# Technical Service Bulletin

**CHECK ENGINE LIGHT ON WITH DTC P2183:00**

**Bulletin No.:** 01-011/17

**Last Issued:** 08/04/2017

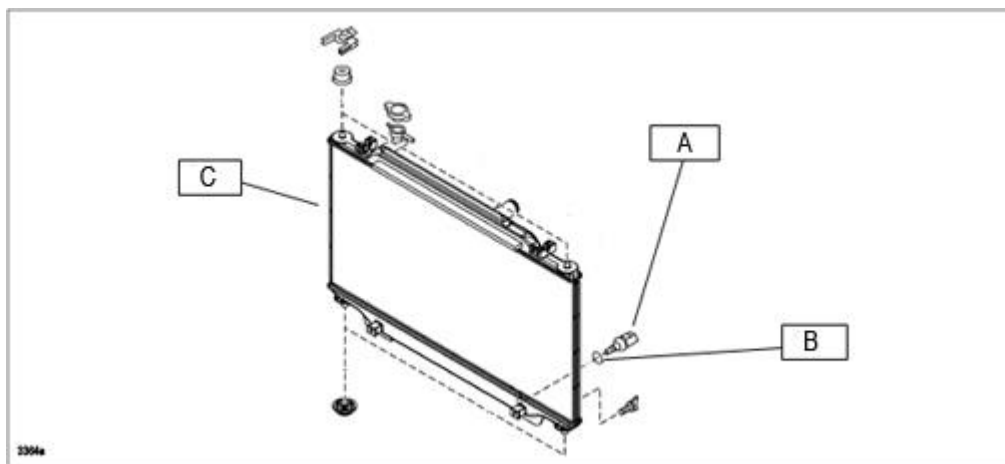
If the ECT sensor No.2 internal circuit is corroded, the sensor output is far below the ECT sensor No.1 output due to higher resistance caused by corrosion.

Determine if the ECT sensor No.2 is malfunctioning by comparing the two sensors outputs.
